'74 EXPO U.S. PAVILION

DESIGN REVIEW BOARD STEP 2 RECOMMENDATION MEETING WRITTEN PROJECT SUMMARY

Spokane Parks and Recreation

Submittal Date: 1.24.18

2E - FURNISHINGS & FIXTURES | MASTER PLAN

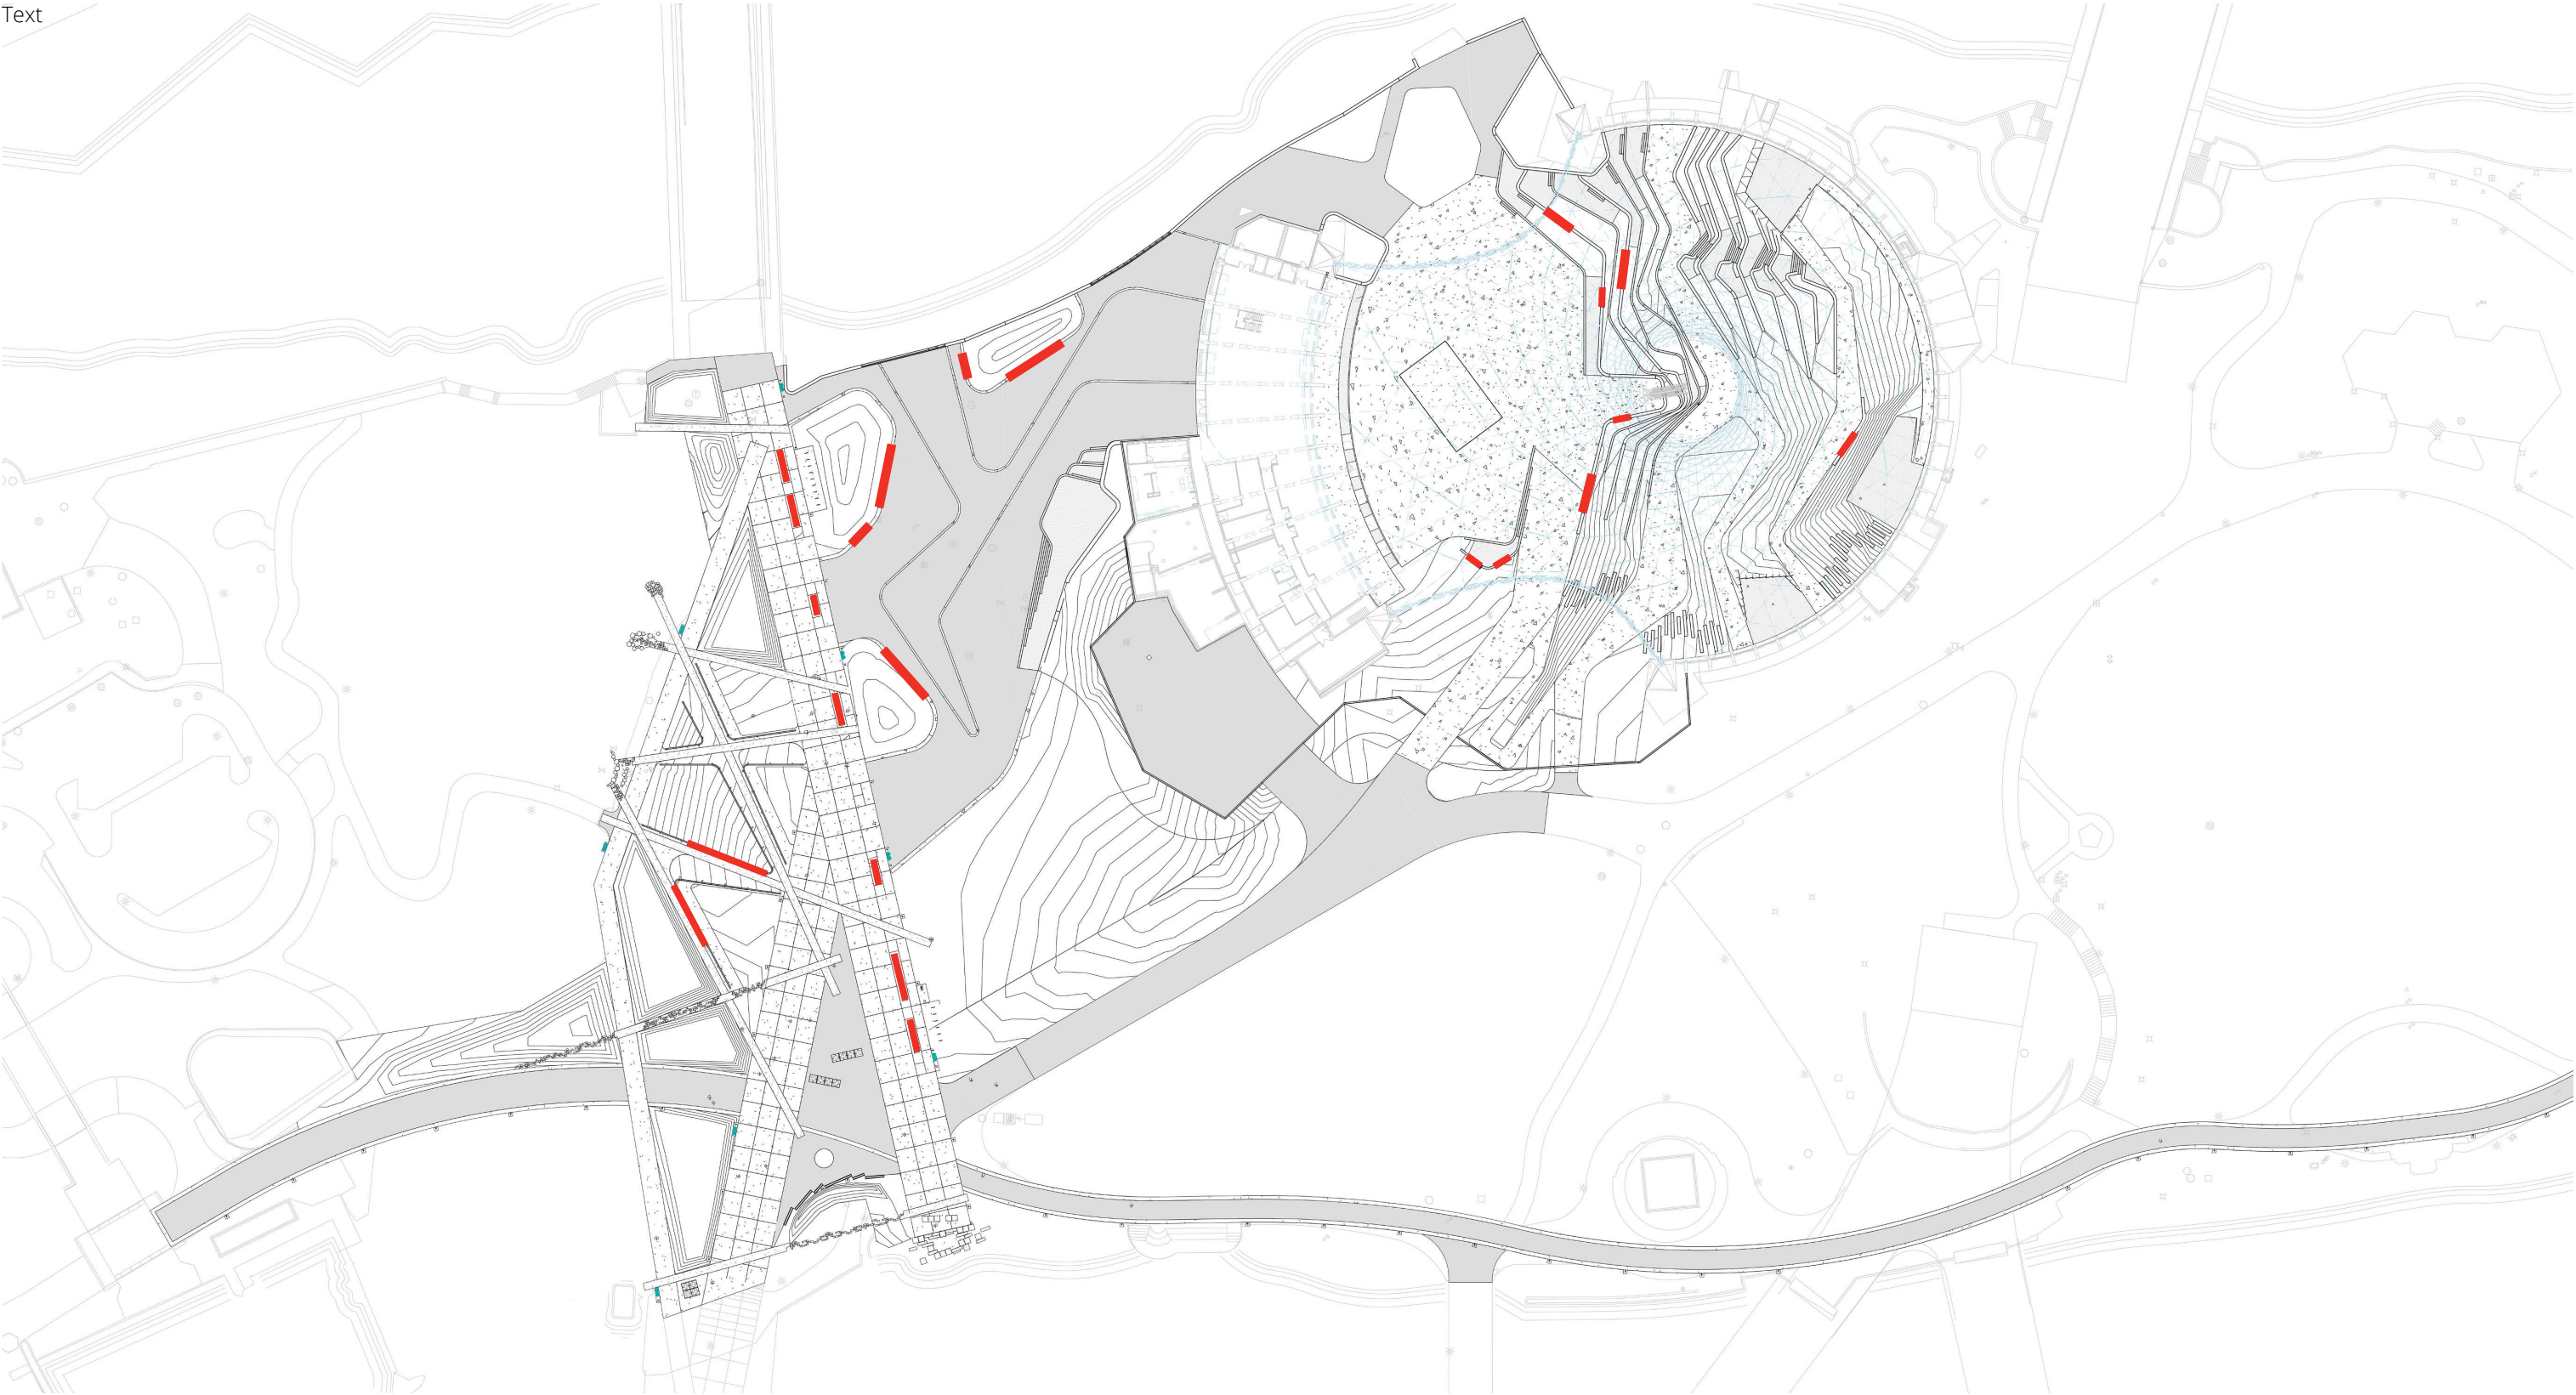
FURTHER DEFINE HOW FURNISHINGS AND FIXTURES WILL BE INCORPORATED INTO THE PROJECT TO MEET THE DESIGN OBJECTIVES.

2F - SITE LIGHTING

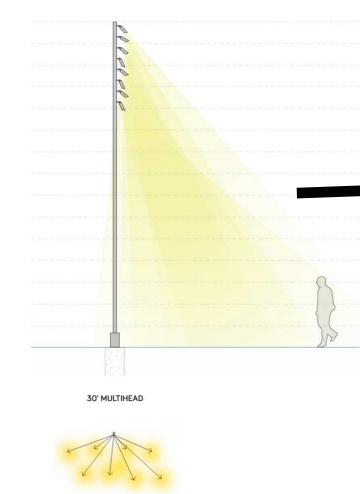
FURTHER DEFINE HOW GENERAL (NON-EVENT) LIGHTING WITHIN THE RING OF THE U.S. PAVILION WILL BE ADDRESSED.

In general, the Pavilion project is broken up into (3) lighting zones: the Central Plaza / Central Green, the Pavilion floor and the Terraces. Each of these lighting zones is treated differently.

- > Central Plaza / Central Green: The general lighting in the Central Plaza and Central Green will utilize the park standard 30' multihead pole. Additional technical information is available in the 2016 Riverfront Park Design Guidelines.
- > Pavilion Floor: The Pavilion Floor is intended to be as open from obstructions as possible. The design team will utilize a combination of flood light fixtures, hung from the cable structure above and wall mounted flood lights. In both cases it is important to avoid glare, especially at the building.
- > Terraces: The design for the terraces will include a combination of flush mounted, wall and step lights. Again, the concept is to minimize pole lights and maximize the openness of the space.
